Re: Utility PURPA Compliance Filings –  
Comments on PacifiCorp PURPA Compliance Filing

Docket Nos. UE-190663 – Avista  
UE-190665 – Puget Sound Energy  
UE-190666 – PacifiCorp

**Figure F.17 - Comparison of Reserve Requirements and Resources, West Balancing Authority Area (MW)**

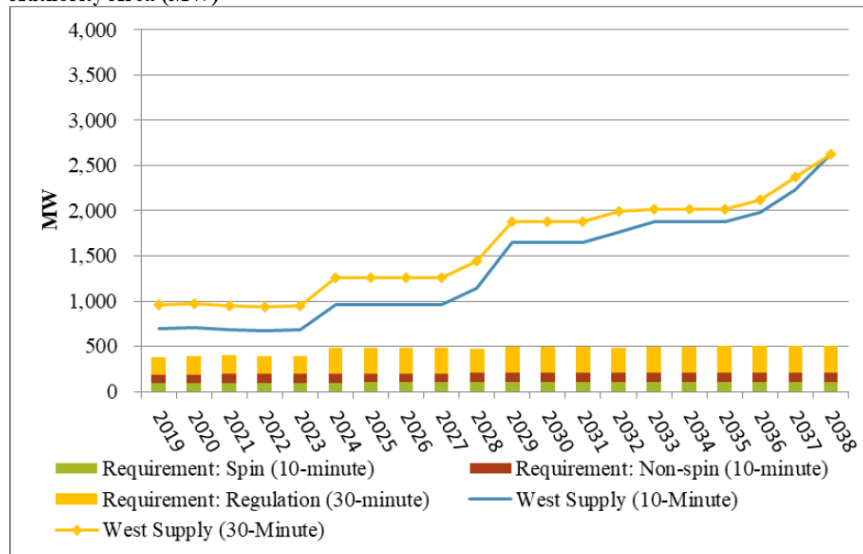
Additionally, PacifiCorp has adequate reserve requirements:

Therefore, with excess reserves, PacifiCorp’s estimate of “capitalized energy costs” is grossly overstated and without foundation.
